4 October 2016

1. This report forms an addendum to arboricultural assessment report prepared by Tree Logic for Japara Health Care, as part of the aged care development at 35 - 39 Regent Street, Mount Waverley (Ref No. 7216)

Diagram 1: Indicative ground protection system - adapted from AS4970 Clause 4.5.3 Ground protection

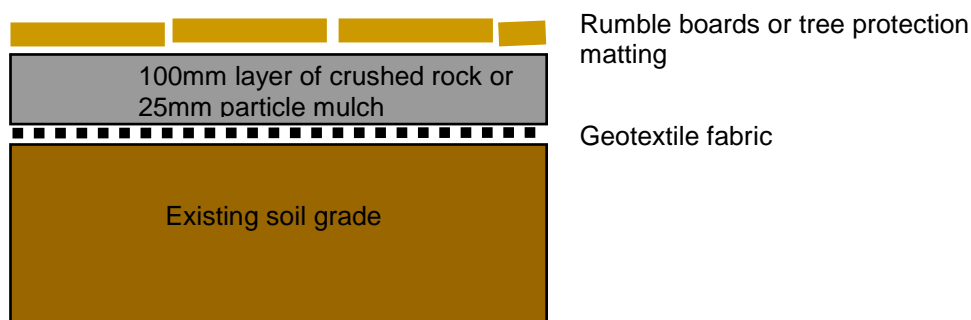
The TPZ areas can be temporarily encroached if the area is protected. Measures may include a permeable membrane, such as a geotextile, to cover the TPZ area beneath a 100 mm layer of crushed rock below rumble boards or tree protection matting, such as Economat™ (See Diagram 1). This will allow temporary access.

- No need to remove organic matter layer. Close mow of all grass within area. If excavation is required to attain levels, no more than 100 mm in depth is to be removed.
- The entire area is to be covered with a geotextile fabric that will extend beyond the area by a distance to account for any crimping when a surface material is laid on top. Geotextile to be firmly anchored into the soil. The geo-fabric shall comprise Bidim U34 filter fabric or equivalent. Installed by hand.
- When installing the GPS, work from the existing hard surfaces towards the extremities, using a mini tracked excavator to transport the rock material. Excavator is to always work on installed GPS.
- When dismantling, work from the extremities back towards the existing hard surfaces. Using a mini tracked excavator. Excavator to always work on remaining GPS.
- Geotextile comes up last (by hand).
- Reinstall grass.
